Recall Bulletin

PRODUCT SAFETY RECALL

SUBJECT: Hood Striker Corrosion

MODELS: 2013-2015 Chevrolet Spark

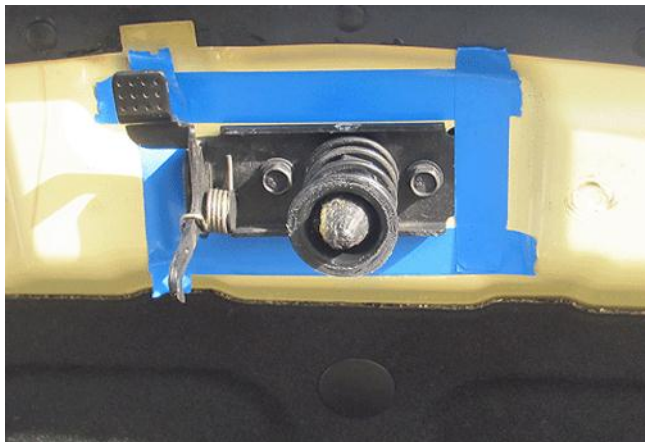
General Motors has decided that a defect which relates to motor vehicle safety exists in certain 2013-2015 model year Chevrolet Spark vehicles. The involved vehicles were manufactured with a secondary hood latch that may prematurely corrode at the latch pivot causing the striker to get stuck out of position and preventing the striker from properly engaging the hood latch. If the secondary latch corrodes causing the striker to be stuck out of position, and the primary latch is not engaged, it is possible that the vehicle's hood may open unexpectedly. If the hood opened unexpectedly while the vehicle is being driven, the driver's vision will likely be impaired increasing the risk of a vehicle crash.

Dealers will replace the striker with a new part which has superior corrosion protection.

1. Raise the hood.
2. Locate the hood latch striker assembly, mounted on the hood.

3. Using masking tape, mark the location of the striker assembly.
4. Remove the striker assembly. Save the fasteners, they will be reused.
5. Install the new striker assembly. Align the striker using the masking tape.
6. **Tighten** 8.5 N.m (75 lb in).
7. Inspect the hood for proper alignment.
8. Remove the masking tape from the hood.
